Randwick Local Planning Panel (Public) Meeting

Subject: 169 Rainbow Street, Randwick (DA/424/2022)

Proposal:	Alterations and additions to the existing dwelling house including new rear roofed patio with subfloor storage area and associated works.
Ward:	East Ward
Applicant:	Mr J Spiteri
Owner:	Mr M A Archer & Ms C Christian
Cost of works:	\$165,000
Reason for referral:	More than 10 unique submissions by way of objection were received

Figure 1. Proposed site plan – 169 Rainbow Street, Randwick

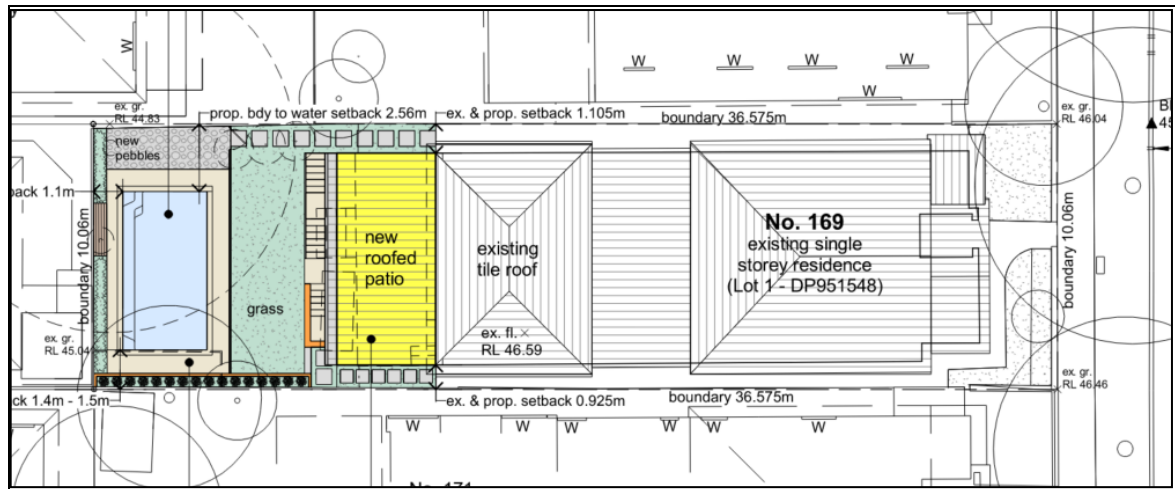
Amended plans were received on 24 October 2022, with revisions to the proposed deep soil area.

The key issues associated with the proposal relate to earthworks and privacy.

- The louvre panels on the eastern and western elevation of the proposed patio must be fixed, with either:
 - Individual openings not more than 30mm wide;
 - Individual blades angled and spaced appropriately to prevent overlooking into the private open space or windows of the adjacent dwellings.
- This development consent relates to the new roofed patio and lower ground floor store room only. This consent does not grant approval for the swimming pool and associated retaining walls and landscaping. The plans are to be amended prior to the issue of the Construction
